Product Change Notification / SYST-28NGOB303

ERRATA - ATmega640/1280/1281/2560/2561 Silicon Errata and Data Sheet Clarification

Description of Change:The initial release of this document

ATmega640/1280/1281/2560/2561 Silicon Errata and Data Sheet Clarification

3.1 Errata Section in Data Sheet is no Longer Valid

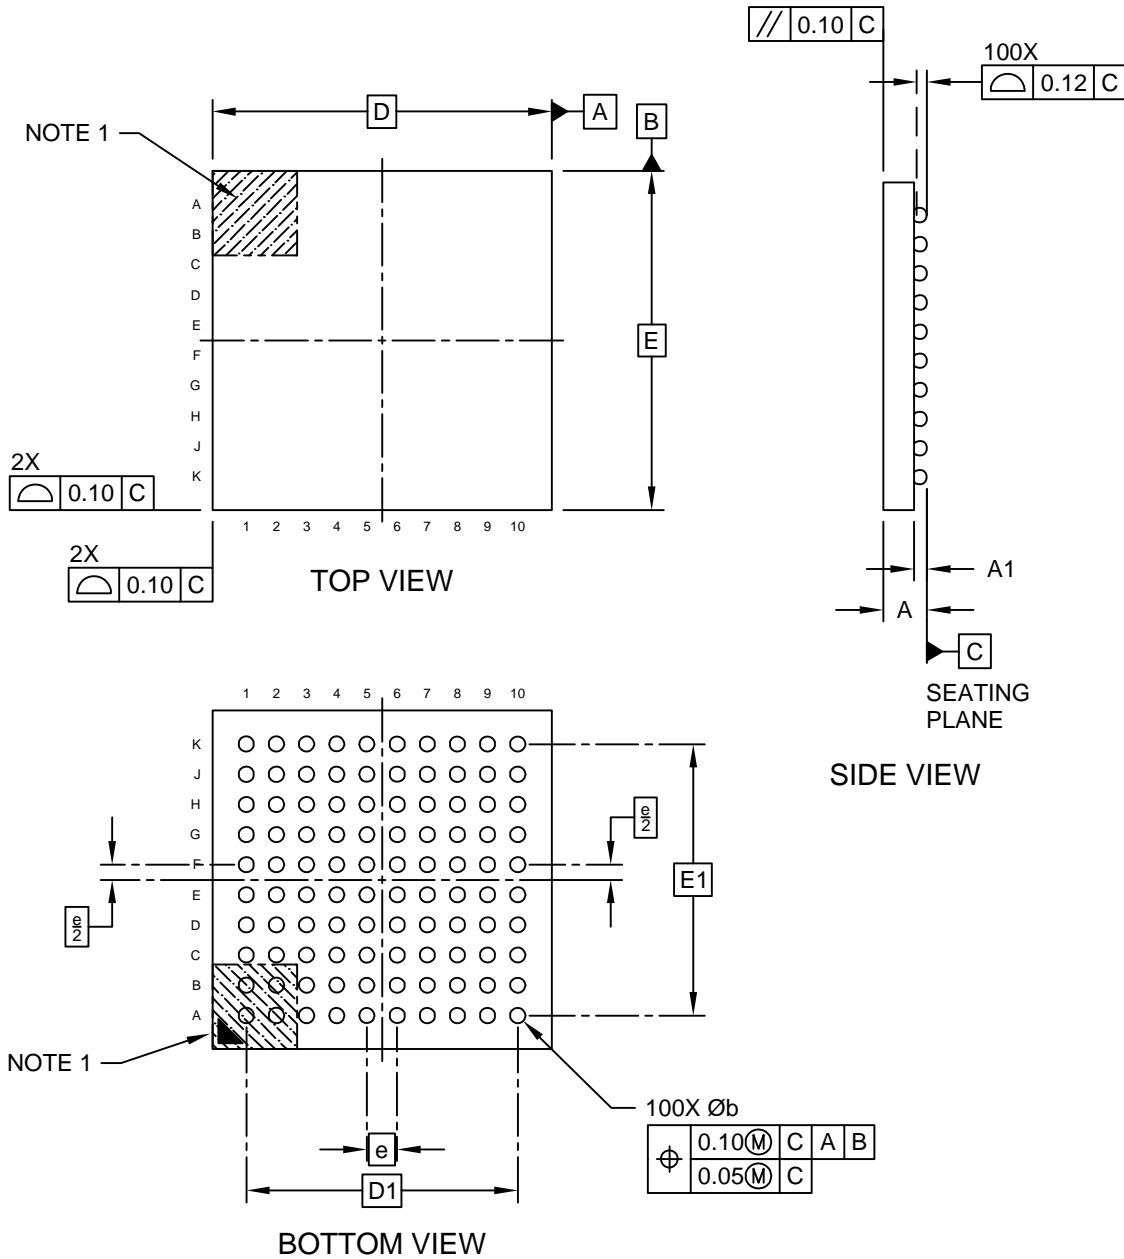
A clarification for the Errata section in the device data sheet has been made.

The errata content has been moved to a separate document, *ATmega640/1280/1281/2560/2561 Silicon Errata and Data Sheet Clarifications* (this document).

See the *Silicon Errata Issues* section of this document for the latest errata.

3.2.1 100-Ball CBGA

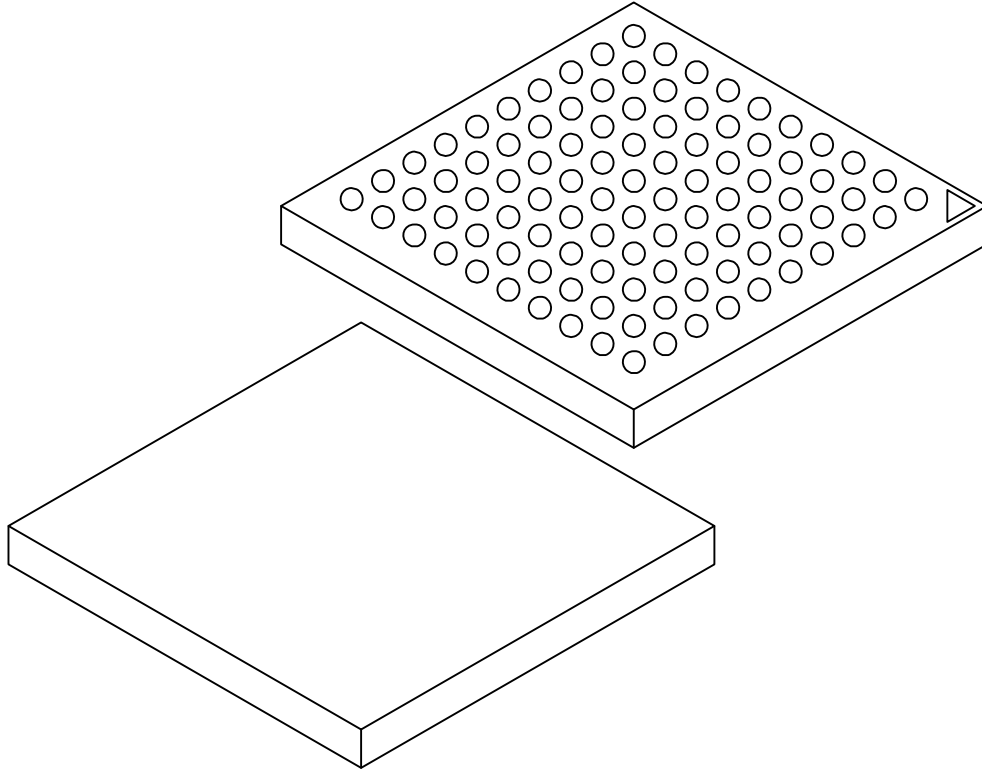
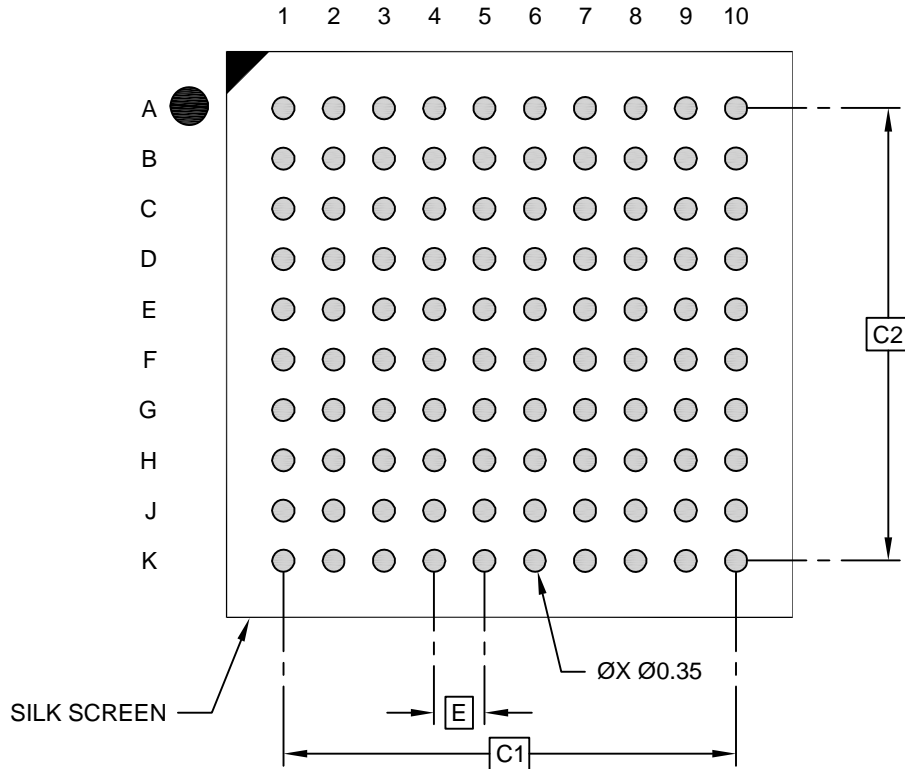
100-Ball Ceramic Ball Grid Array Package (A3B) - 9x9 mm Body [CBGA] Atmel Legacy Global Package Code CPR

100-Ball Ceramic Ball Grid Array Package (A3B) - 9x9 mm Body [CBGA] Atmel Legacy Global Package Code CPR

Figure 3-1. Clock Distribution

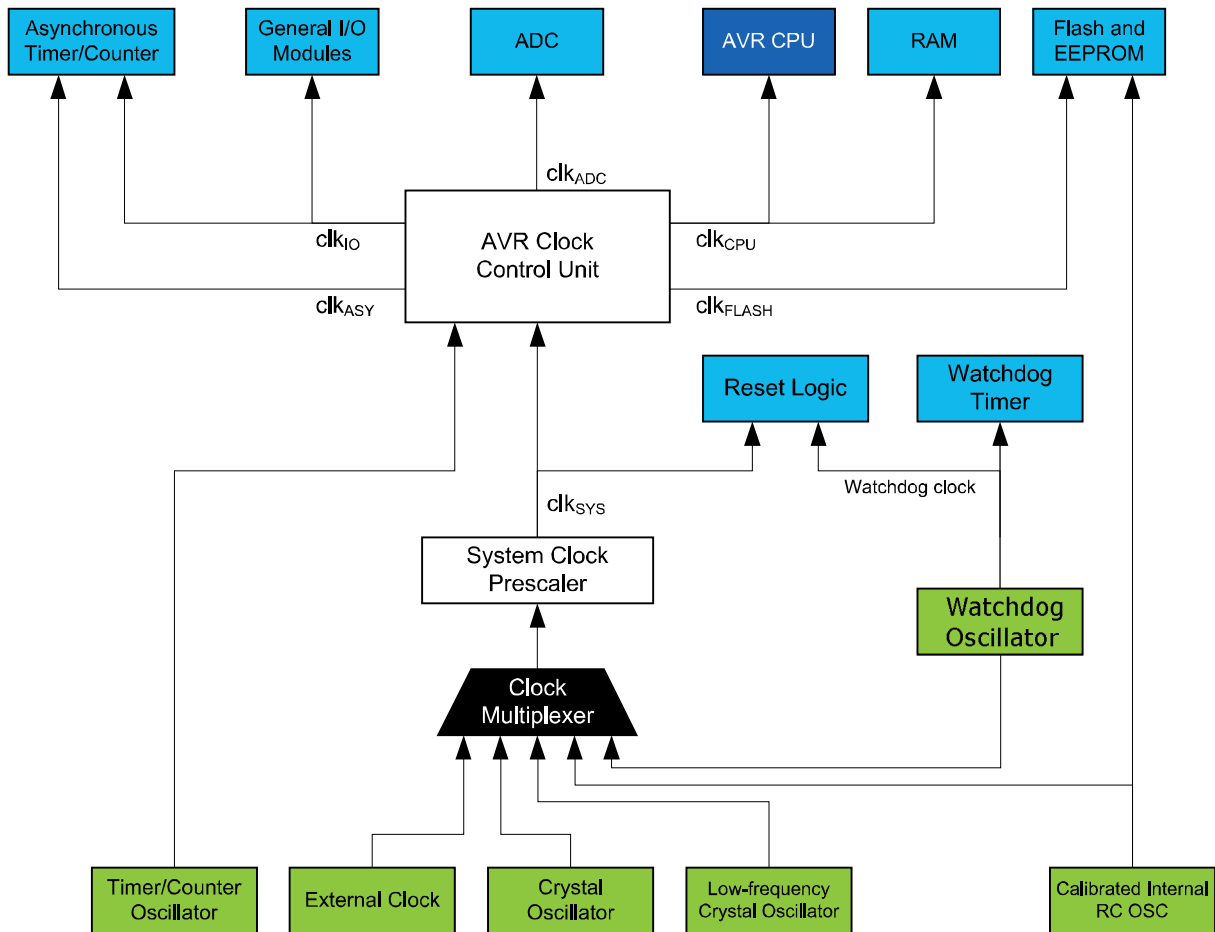
A clarification for the “*Clock Systems and Their Distribution*” section has been made.

Figure “*Clock Distribution*” presents the different clock systems in the ATmega640/1280/1281/2560/2561 and their distribution. All of the clocks need not be active at a given time. The clocks to modules not being used can be halted using different sleep modes, as described in the “*Power management and Sleep Modes*” section, to reduce the power consumption.

Figure 3-2. Output Compare Modulator, Timing Diagram

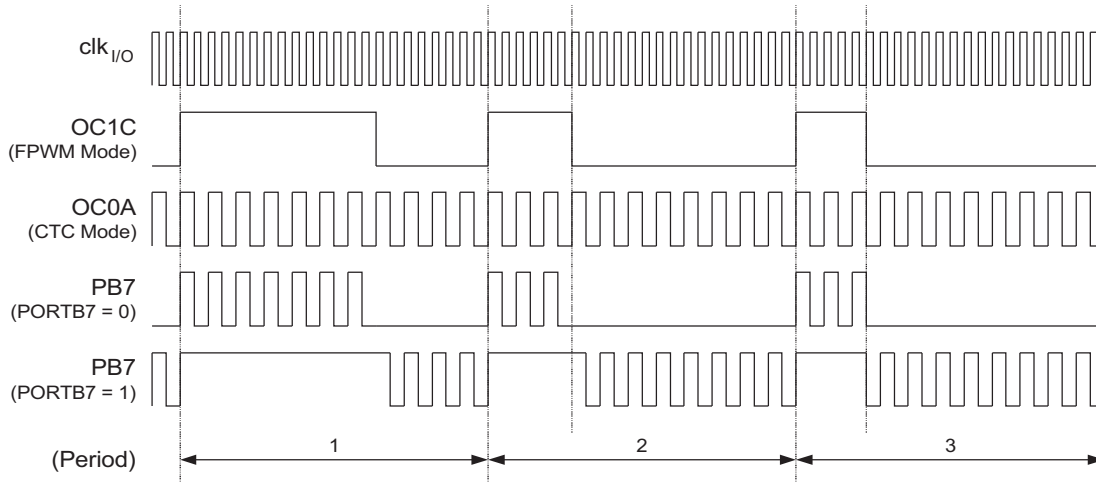
A clarification for the “Timing example in the Output Compare Modulator” has been made.

The following figure illustrates the modulator in action. In this example, the Timer/Counter1 is set to operate in fast PWM mode (non-inverted), and Timer/Counter0 uses CTC waveform mode with toggle Compare Output mode (COMnx1:0 = 1).

In this example, **Timer/Counter0** provides the carrier, while the modulating signal is generated by the Output Compare unit C of the Timer/Counter1.
